BULLETIN TITLE: SEAT ATTACHMENT	
	CLASSIFICATION: SAFETY DIRECTIVE/SAFETY ALERT	
Letecká 255 686 04 Kunovice Czech Republic	Tel.:+420 773 984 338 info@brmaero.com www.brmaero.com	BULLETIN NUMBER: ALL-SA-0-0-0-ALL-0002-2021 Date of issue: 11.11.2021 Date of effect: 11.11.2021
		Revision no.: New issue Date of rev.: - Page: 1 Pages: 8

Seat attachment - photos

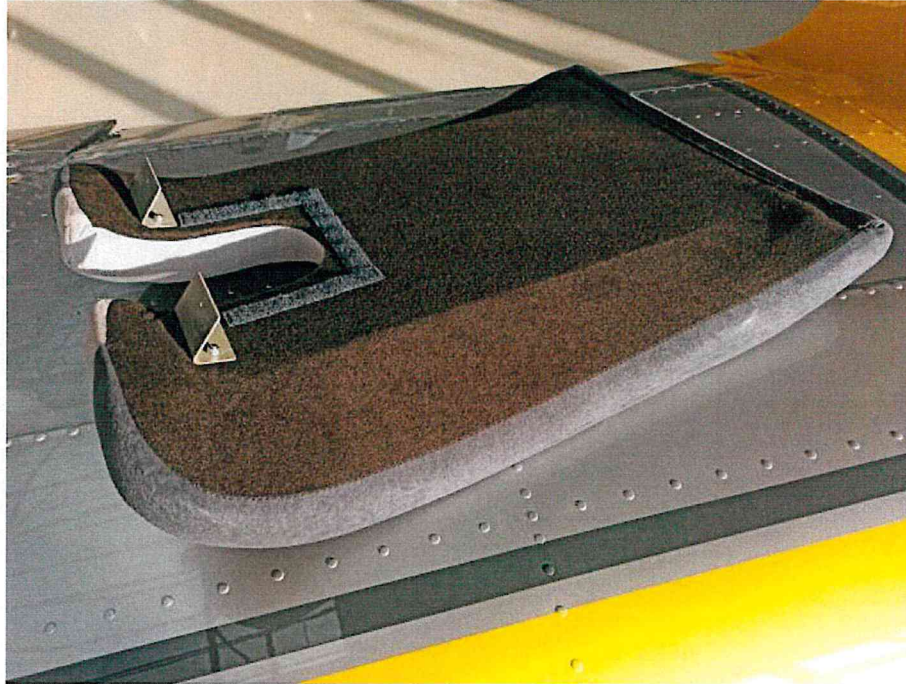
When operating Bristell aircraft with the original design of the seat attachment (see Figure 1), it has been found, that the seat can move up and forward, which may cause reduction of elevator fully aft deflection (see Figure 6).
This situation can occur for example, with an unoccupied seat when flying in turbulence or through a gust, when the seat is incorrectly fitted or when the pilot is settling into the seat.

If the seat can be lifted up easily, it is the original design with the straight brackets, see Figure 1.

If the seat cannot be lifted up easily, it is a new design (Figure 2) which holds the seat sufficiently. In this case the brackets do not need to be changed and record the compliance with the bulletin in the Aircraft LogBook.

Figure 6 Control stick fully aft limited deflection if the seat jumps up and forward (the console gets in front of the main spar, see arrow).

Check of both seats attachment.
Replacement of the seat brackets (4 pcs/per 1 aircraft) with new design.

Before the next take-off check the seat attachment (see Figure 3).
Before each take-off, the pilot should always check the possibility of full deflections of the control surfaces, including elevator in the fully aft direction.
At the next periodic inspection, but no later than 1 year from the date of issue of this bulletin, replace the original seat brackets with the new design.

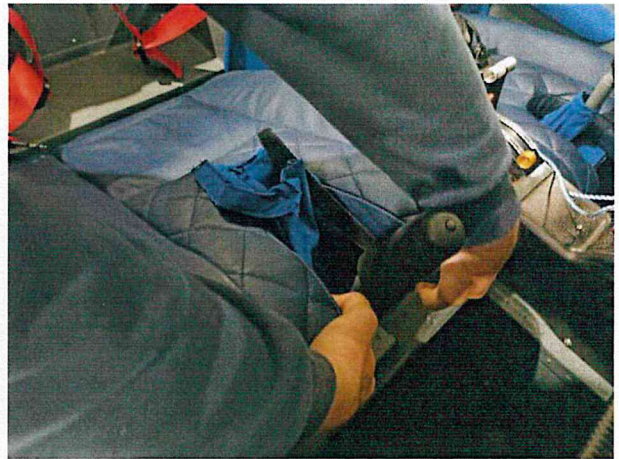
Redrill holes through the new brackets using 5mm drill bit.

Set the new brackets on the seat.

Screw and gently tight the nuts.

Do the same for the other brackets.

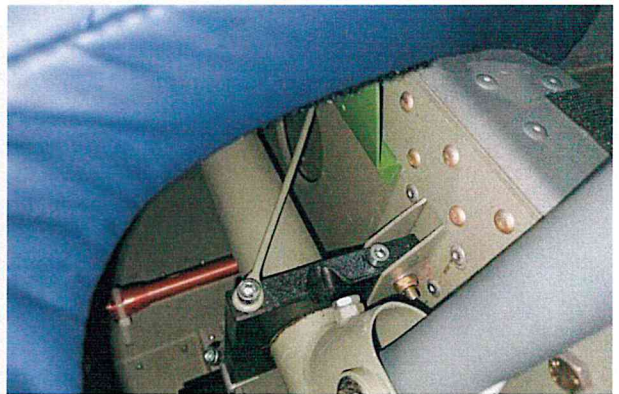
Re-install the seat back into the fuselage and check seat attachment firmness. If the seat is hardly to insert, push the bracket ends slightly rearward.

If needed to adjust firmness of the seat attachment in the fuselage, bent slightly the brackets (rearward to reduce attachment force and seat easier insertion into the fuselage), forward in-flight direction to increase seat firmness.

The brackets shall lock under the center spar upper flange. The seat may not be possible to easily lift up, it must hold in the fuselage.

IMPORTANT! Check there are no collisions of the new brackets with the surrounding construction, control system or installations in the fuselage.
